0.0 Planning Application PLN25/0134 at 35-41 Taunton Street, Doncaster East for the construction of 30, two-storey dwellings

File Number:	IN25/824
Responsible Director:	Director City Planning and Liveability
Applicant:	Taunton St (AZ & CXW) Pty Ltd
Planning Controls:	General Residential Zone 3
Ward:	Waldau
Attachments:	1 Legislative Requirements PLN25 0134 2 Confidential Objector Map PLN25 0134 3 Decision Plans PLN25 0134 4 Decision Landscape Plan PLN25 0134 5 Decision 3D Render Views PLN25 0134

Figures: annotations by Council's Planning Arborist on External Works Plan extract

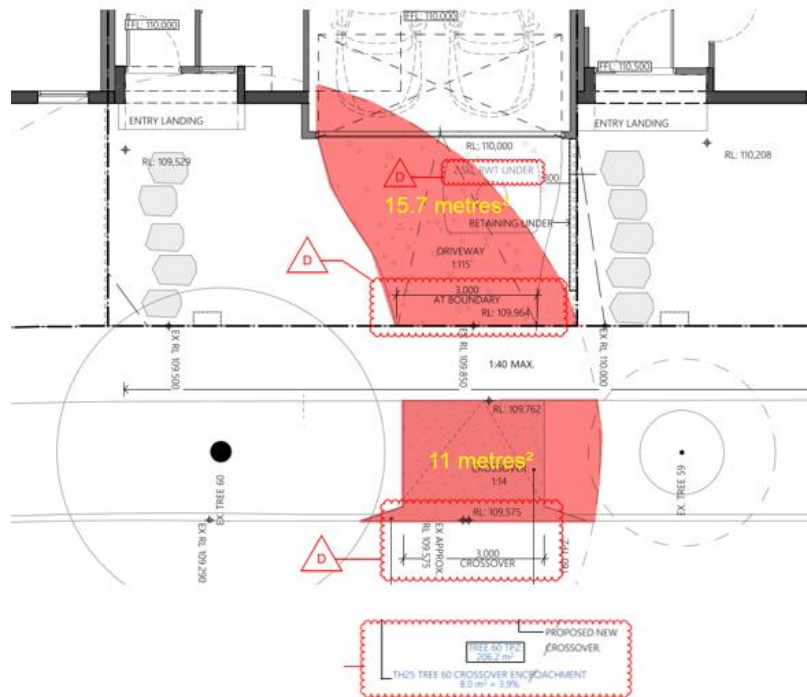
- 7.23 Standard B2-6 (Access) is **not met**. The accessways and vehicle crossovers encroach the tree protection zone of existing *Melaleuca* street trees 60 & 62 by 13% and 25.7% respectively, which is more than the maximum 10% encroachment allowed by the Standard. This encroachment is calculated by including both crossovers and accessways (driveways) within the site within the TPZ, and including the lost area within the TPZ beyond the excavated

crossovers/driveways which cut all root zones beyond. This is expanded on in the Clause 55 assessment, with the encroachment correctly shown in the annotated diagrams below:

This 'applicable' standard **is not met** as the accessways and vehicle crossovers encroach the tree protection zone of the existing *Melaleuca* street trees 60 and 62 by more than 10%. The applicant considered only the impact of the crossover on the street tree, failing to add the encroachment of the new accessways (driveways) within the site, (per its definition by the Department of Transport and Planning), nor was the area included beyond the new excavated crossovers/driveways. The TPZ area east of the crossover and north of the driveway within the garage are also considered lost (per the definitions of encroachment under Australian Standard AS4970-2025). Any roots in this area would also be lost from the excavation required to construct the crossover or driveway. Therefore, encroachment into the TPZ of Tree 60 will be 13% (26.7 of 206.2 square metres) and encroachment into the TPZ of Tree 62 will be 25.7% (124.5 of 483.2 square metres).

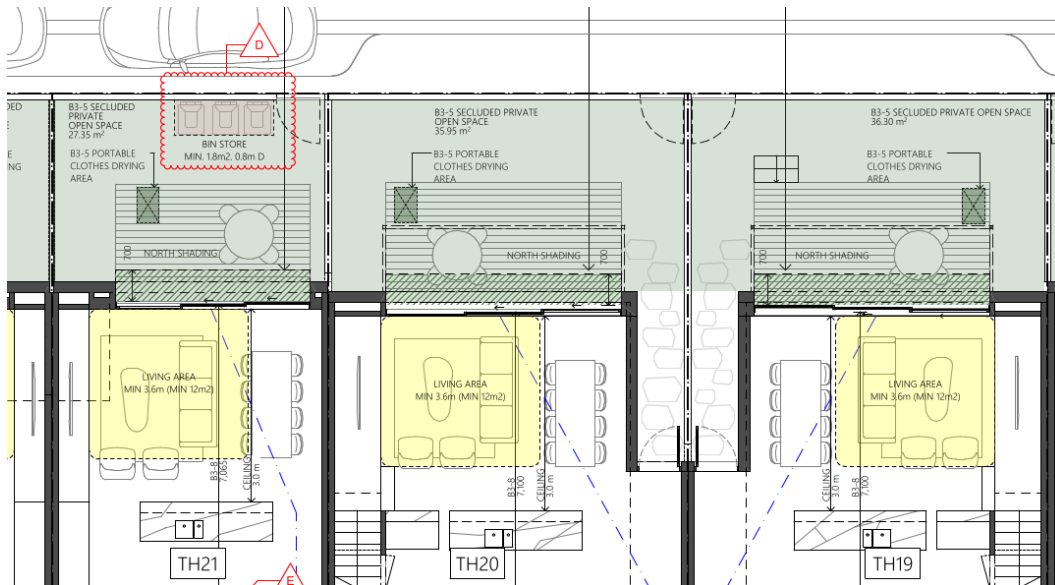
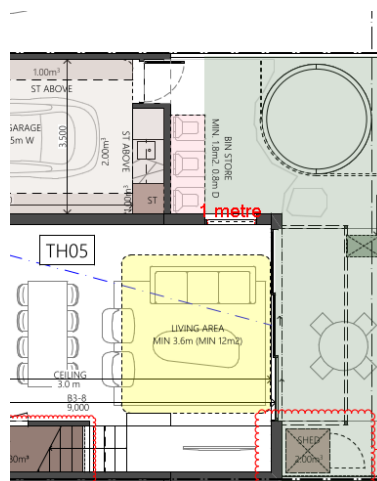
All of the broad ground floor living room north-facing windows are provided with fixed eaves or fixed horizontal eaves as part of pergolas to comply with the standard, as shown on the plan.

The standard is not met in part to the secondary north facing living room windows on dwellings TH01 to 05 which are not protected or shaded, see below. These windows are narrow 1 metre openings and the rooms are predominantly east facing.

The standard is not met for the first floor windows. Instead of providing the required fixed shading, north-facing bedroom windows have solar protection by operable external blinds. A condition will require all first floor north facing windows to comply with Standard B5-4.

- m) All water tanks, sheds, and services located outside the notional root zone of any tree to be retained.
 - n) All first floor north facing windows to comply with Standard B5-4 – Solar Protection to new north facing windows.
